**BEFORE THE PUBLIC UTILITY COMMISSION
OF OREGON**

UE 394

In the Matter of)	
)	
PORTLAND GENERAL ELECTRIC COMPANY,)	OREGON CITIZENS' UTILITY BOARD'S REDACTED EXHIBITS
)	
Request for a General Rate Revision.)	
<hr/>)

Staff of the Public Utility Commission of Oregon (OPUC or Commission) submits these Opening Comments on Portland General Electric's (PGE or Company's) 2019 Integrated Resource Plan (IRP or Plan), filed on July 17, 2019 and Interim Transmission Solution Addendum filed on August 30, 2019. Staff will continue to evaluate the Company's Plan, conduct discovery, and review stakeholders' comments prior to submitting its Final Comments, currently scheduled to be filed on December 3, 2019.

FIGURE 7-13: Cost versus variability for the preferred portfolio

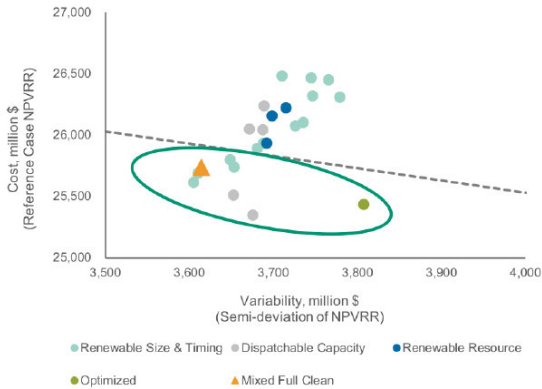
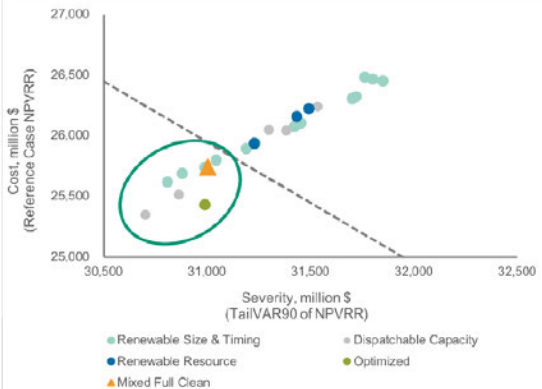
This approach to constructing a new preferred portfolio based on “reasonable actions” from other well performing portfolios is somewhat puzzling, and may present another blunt instrument in portfolio selection. Staff finds this approach particularly curious given that the Mixed Clean Full is outperformed by others in terms of cost and risk, as shown by PGE’s graphics:²⁰

PGE should provide an analysis comparing its preferred portfolio to other top-performing portfolios for cost and risk, and explain why the Company believes it has chosen a portfolio with the best balance of cost and risk, as required by the IRP guidelines.

Recommendation 4: As PGE adjusts its IRP analysis in accordance with Staff's comments, including the removal on non-traditional screens, PGE should provide additional information:

- Provide a quantitative comparison of its preferred portfolio to other well-performing portfolios in terms of NPVRR cost and risk.
- Explain why the Company believes its preferred portfolio has the best balance of cost and risk for customers.

PGE’s Intergenerational Analysis²²

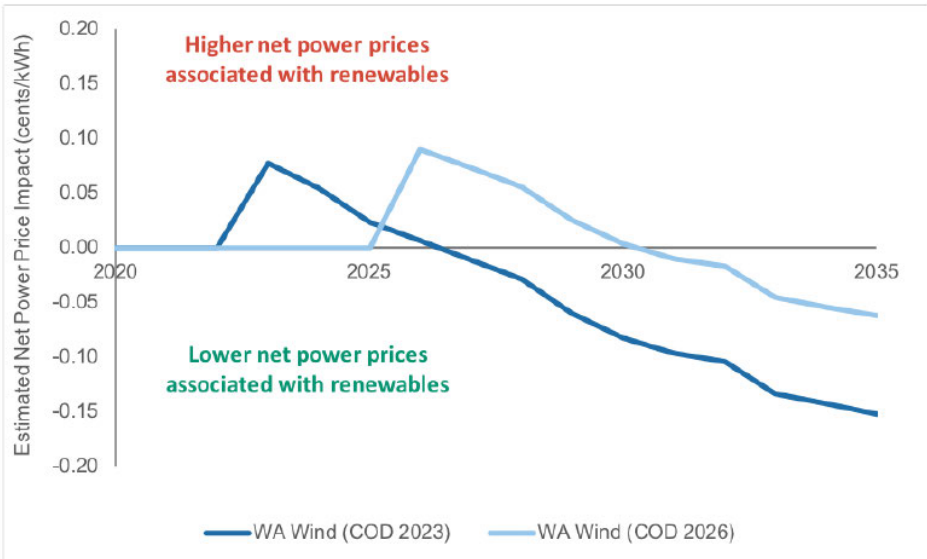
Staff appreciates PGE's inclusion of an analysis of the intergenerational equity implications of its plan to acquire renewable energy in the near-term to capture the expiring PTC. An informed discussion of this issue is important to Staff, as near-term renewables may be part of a least-cost portfolio.

To place additional context on the analysis of a 2026 wind addition, PGE’s Appendix G Load Resource Balance indicates that PGE may have an energy deficit by 2025.²³ Staff will conduct additional analysis to consider how the 0.01 cent difference in customer rates compares to the risk of an energy need in 2025, given other assumptions about load growth, voluntary programs, and new Qualifying Facility (QF) contracts that are discussed elsewhere in Staff opening comments.

Many factors could change the effect that a new resource will have on rates, including resource cost and performance, future market conditions, and future customer demand. Staff will continue to assess the inputs and assumptions behind PGE’s intergenerational equity analysis. For example, the intergenerational equity analysis may utilize some of the same modeling inputs and assumptions that Staff finds concerning or problematic in the 2019 IRP. Staff hopes PGE will participate in a robust assessment and discussion of the intergenerational equity risks of near-term procurement of renewables.

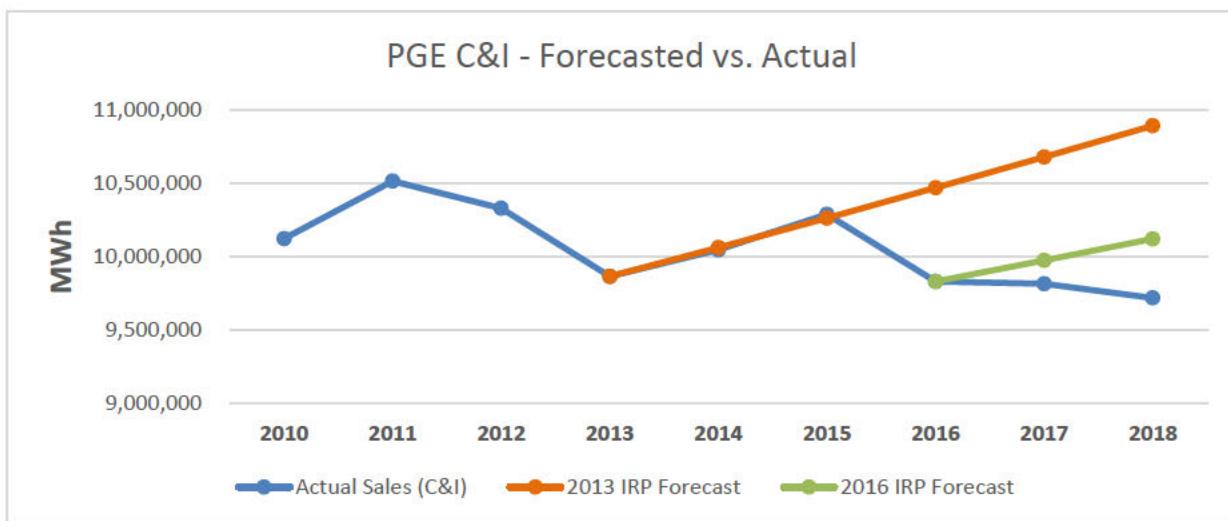
As Staff works with the company on this reconstruction of PGE’s work, Staff is has noted a few new issues with its load forecast. PGE’s rates of projected load growth by customer class in this IRP are modest:

Yet, based on recent trends, Staff is unsure of the accuracy of this IRP’s commercial and industrial load forecasts. Below is a comparison of actual load since 2010 and previous IRP forecasts:⁵²

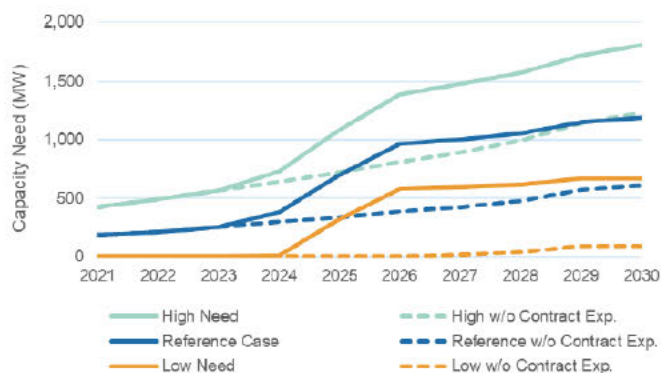
Staff is currently reviewing the forecasted range of capacity needs in the 2019 IRP, which it finds is strikingly broad. Staff is motivated to ensure that the Company gives adequate considerations to capacity adequacy, particularly given the robust discussions in Chapter 3 Futures and Uncertainties and the regional capacity need shown by recent studies evaluated in the Market Capacity Study.⁵⁹

PGE forecasts wide “jaws” of capacity need by 2025, ranging from a low of 0 MW to a high of nearly 1,100 MW of new capacity. The graphic below captures the wide range of possible need.⁶⁰

FIGURE 4-17: Load and existing and contracted generation

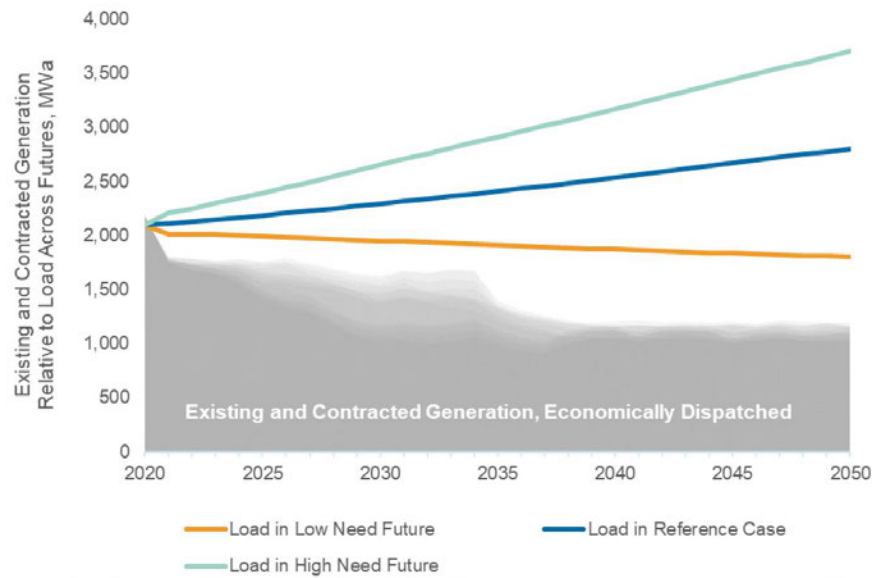
PGE’s new market energy position analysis provides an interesting evolution of the Company’s traditional load-resource balance. Through this analysis, PGE models economic dispatch and compares it to three need futures to demonstrate what it describes as an “energy shortage” (See Figure 4-17).⁶⁶

Yet, when PGE’s resources dispatch economically and market purchases meet the rest of PGE’s load, this is not necessarily an indication that PGE needs to acquire more energy resources. It may simply indicate that market prices are low. PGE’s ‘Market Energy Position’ analysis tells how much energy the company may choose to buy on the market, but in no way should it be used to justify any amount of new resource acquisition.

FIGURE 6-2: Levelized cost of energy (LCOE) of energy resource options

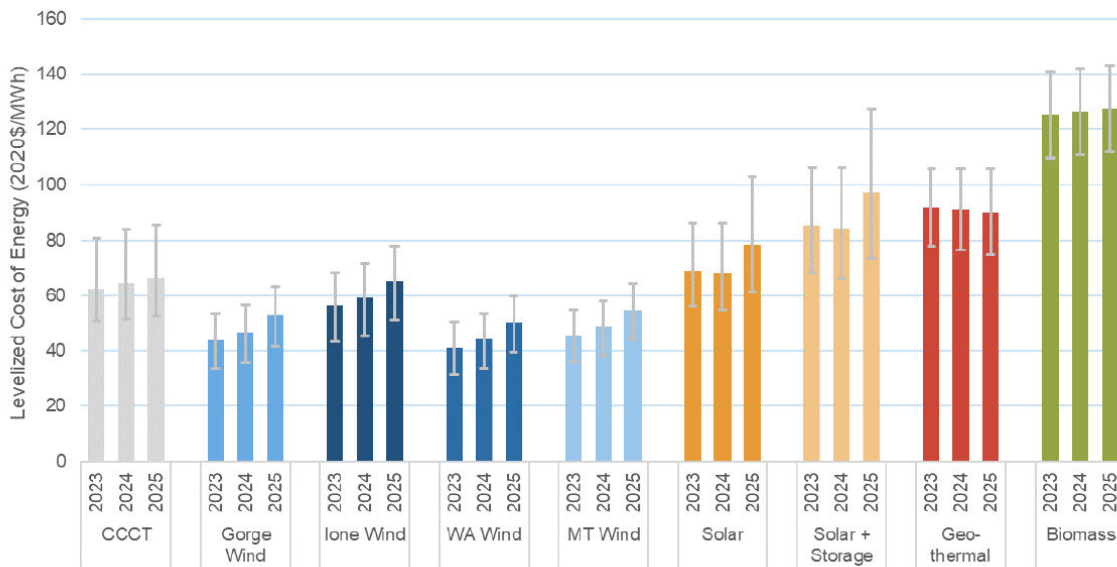
Staff finds this statement generally true and believes the IRP does a good job of demonstrating the production risk associated with capacity factor sensitivity in Section 6.5.⁸² However, Staff would like to better understand how the many assumptions underlying this conclusion were captured in the portfolio modeling and selection. Given that the main driver for the near-term acquisition of wind resources is not energy, capacity, or an RPS need, but rather the time-limited economic opportunity associated with expiring PTCs, Staff’s review is focused on understanding the Company’s assumptions around the federal tax incentives and overall performance of renewable energy resources compared to conventional resources (See Figure 6-2 below).⁸³

FIGURE 6-15: Net cost sensitivities for wind

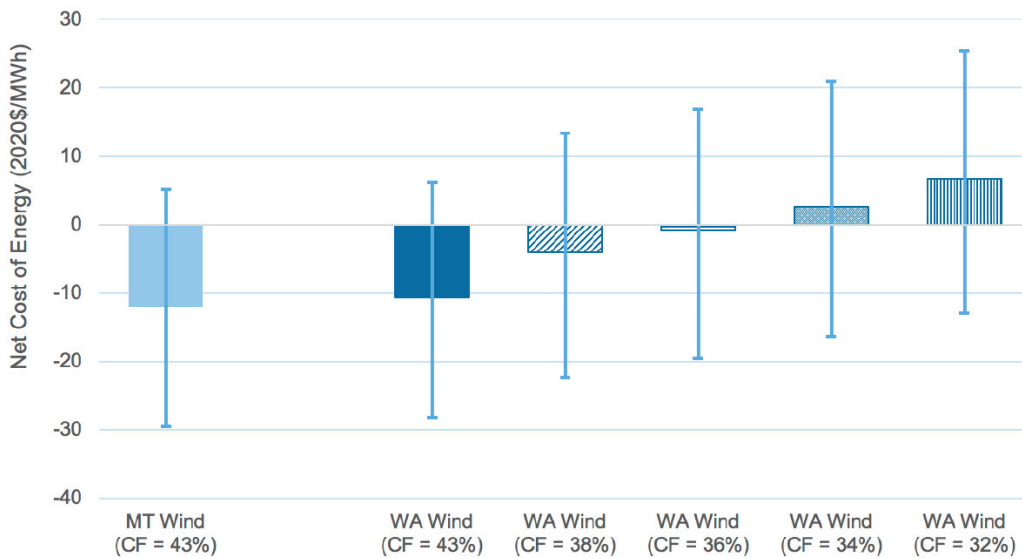
Staff particularly appreciates the sensitivity analysis for wind capacity factors provided in Section 6.5 and Figure 6-15 below.⁸⁹

Staff notes the impact that capacity factor assumptions have on the economic performance of wind resources in PGE’s sensitivity and questions whether the Company’s sensitivity analysis should have been performed on the Mixed Full Clean portfolio to help characterize the risk of acquiring near-term wind assets based primarily on economic performance.

Recommendation 20: Staff requests that PGE provide a sensitivity analysis of the Mixed Full Clean portfolio assuming proportionate changes to the capacity factor of each resource as the assumptions behind the capacity factor sensitivity analysis in Figure 6-15 above.

FIGURE 5-4: Average monthly wind capacity factors by location

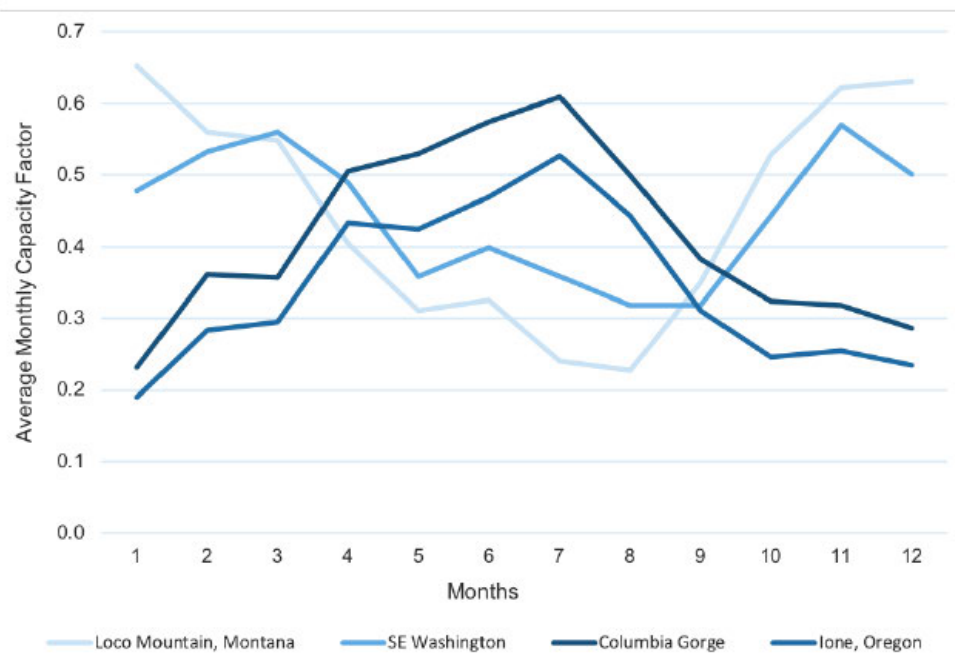
Further, Staff is curious about the relationship between the capacity factor shape of different wind resources modeled in the IRP and PGE’s projected capacity needs. For example, PGE provided a helpful characterization of different wind resources’ capacity factor shapes in Figure 5-4.⁹⁰ Staff notes that the performance of Columbia Gorge and Lone, Oregon wind follow the reverse shape to that of Montana and Washington wind.

FIGURE 4-14: Reference Case loss-of-load expectation in 2025

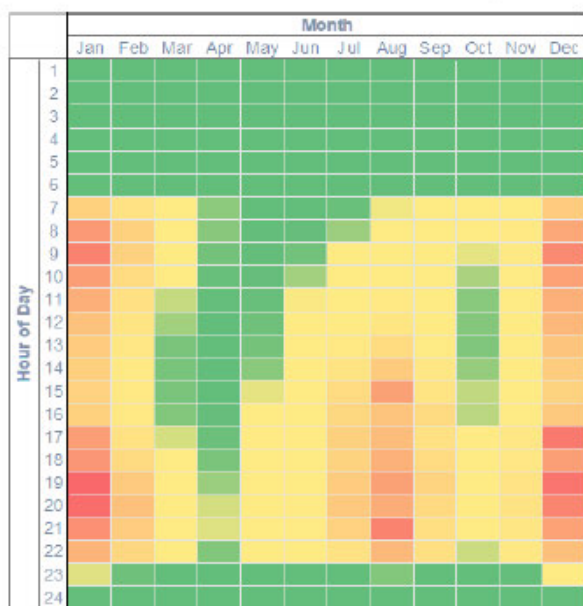
Given the Action Plan’s lack of specificity regarding resources in the renewable RFP and the future capacity actions, it is particularly interesting to note the relationship between the wind shapes and PGE’s characterization of its capacity need found in figure 4-14.⁹¹
